APPENDIX B – TECHNICAL REPORTS AND REVIEWS

SUBJECT: **LUC-2015-469, 147 CHURCH ROAD. PROPOSED COMMUNITY WIND TURBINES. COMMENT FROM LANDSCAPE ARCHITECT.**

Review of Acoustic Assessment

Blueskin Wind Cluster Dunedin

Figure A: Wind turbine generators and receiver locations as set out in Chiles Report.

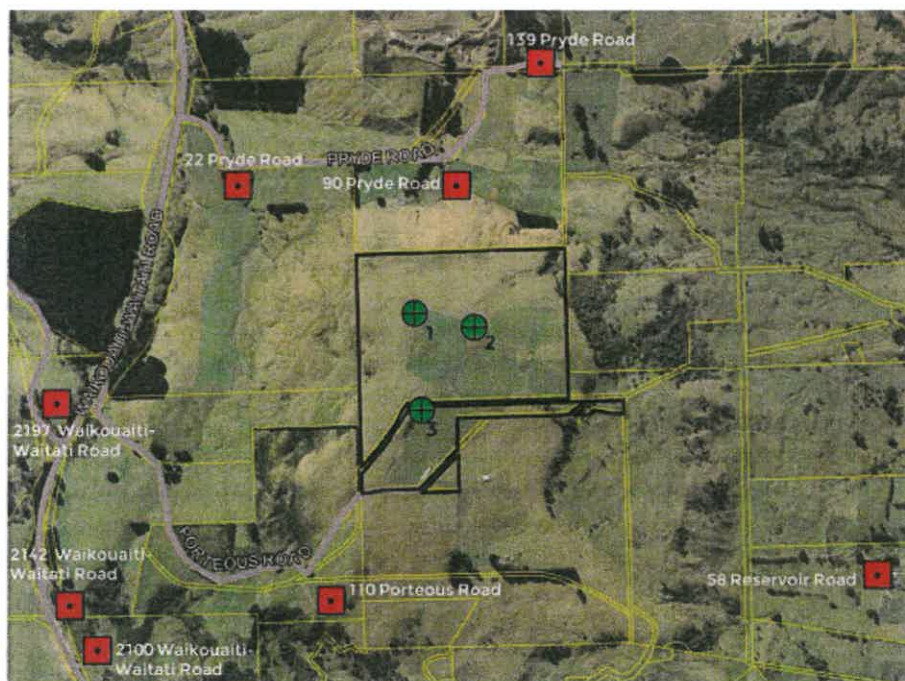
The locations of the proposed wind turbines and the nearest residential neighbors is clearly shown in Figure 1 of the Chiles Report, reproduced as follows as Figure A.

As part of our desk top review we have verified the distances provided based map co-ordinates provided and available aerial imagery. We note that without actually visiting the site and undertaking our own GPS coordinates this information appears to be accurate. We provide the following sample in Table A which is based on our analysis and review of the distance between Turbine 1 and No 90 Pryde Road.

As indicated in Table A we arrive at the same distance calculation as in the Chiles Report, noting that the distances provided in the Chiles report are worst case 'as the crow flies' from the base of the turbine to the dwellings adjacent.

Figure 2: Predicted worst case wind turbine generators noise emission and adjacent receiver locations as set out in Chiles Report.

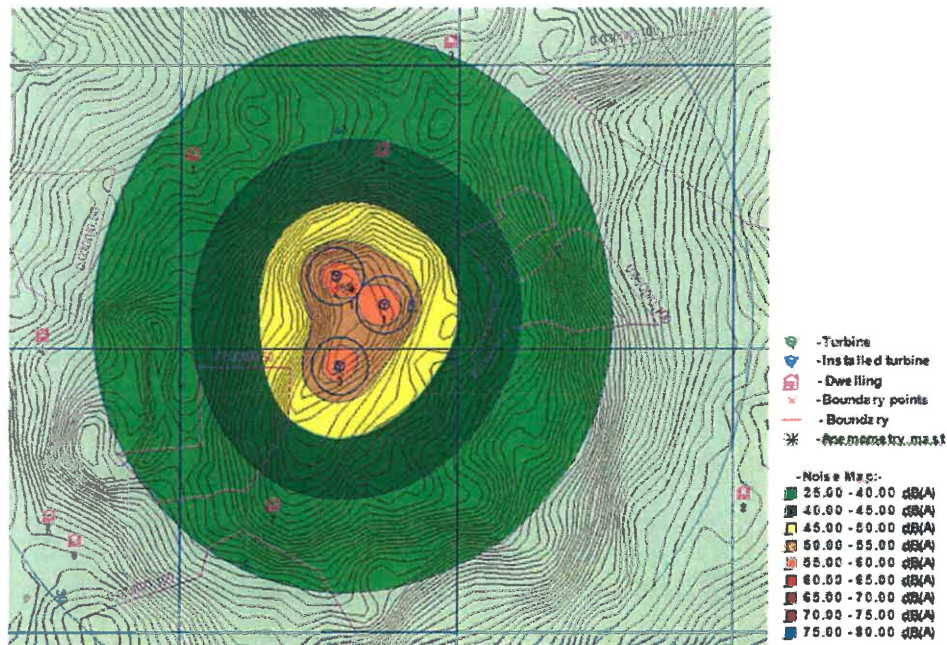
Prediction results quoted in the Chiles Report are without terrain screening, which allows for a conservative assessment. The predicted wind farm sound emission levels are therefore worst case as they assume all wind turbine generators operating simultaneously and continuously at maximum rated sound power levels, a not unreasonable scenario.

We note that NZS 6808:2010 only requires assessment of 95% of maximum rated sound power, regardless the difference between 100% and 95% rated sound power is generally only small in terms of noise output [with 1 dB].

Overall we consider the noise modeling methods to be reasonable and the output reasonably reliable as an estimate of future cumulative noise emitted from the site.
